UNITED STATES
NUCLEAR REGULATORY COMMISSION
WASHINGTON, D. C. 20555

FACILITY: Oyster Creek Nuclear Generating Station

SUBJECT: MEETING OF OCTOBER 9, 1985, ON THE STAFF'S EVALUATION OF THE
DETAILED CONTROL ROOM DESIGN REVIEW, NUREG-0737 ITEM I.D.1

ATTACHMENT 4

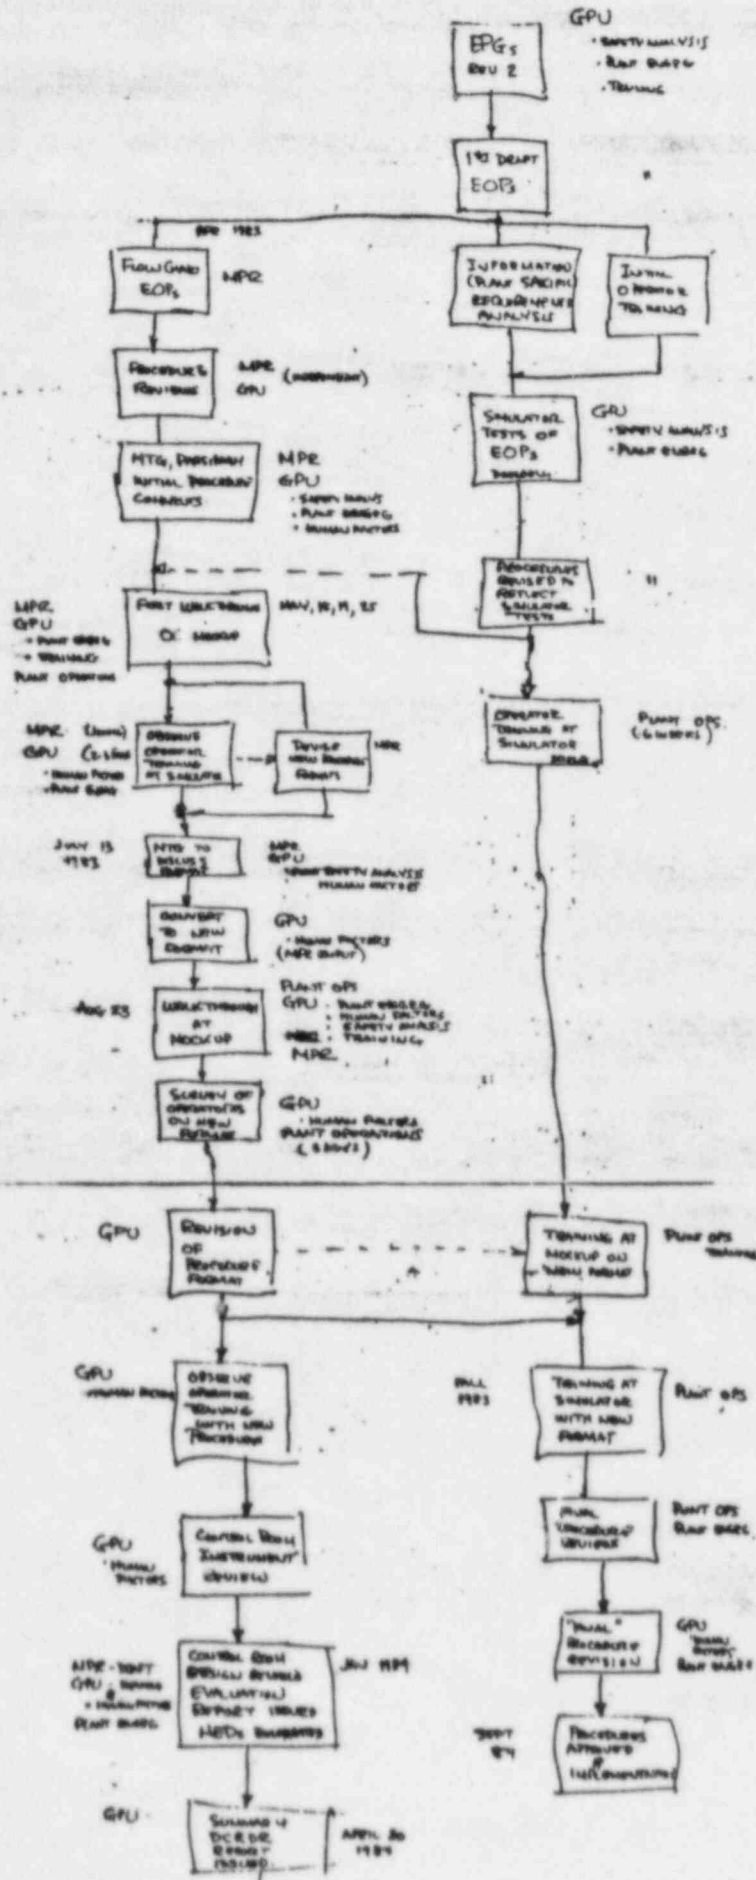
The staff stated an acceptable method to document the past Function and Task Analyses is to describe in detail the flow chart of the process the licensee went through to do its Function and Task Analysis. This chart was a licensee chart exhibit in the November 1-2, 1985, meeting at the licensee's contractor's place of business (See Attachment No. 4). The details have been described by the licensee in the meetings of November 1, 2 and 28, 1984, but no written documentation of these details have been provided by the licensee to the staff. The staff needs this documentation to complete its review and prepare a final safety evaluation on the licensee's DCRDR. The staff is in agreement with these details previously described by the licensee.

- (1) The licensee will describe in detail by letter the processes or steps in its Function and Task Analysis previously used for Revisions 1 and 2 of the EPGs. An acceptable method is to describe in detail the flow chart in Attachment 4.
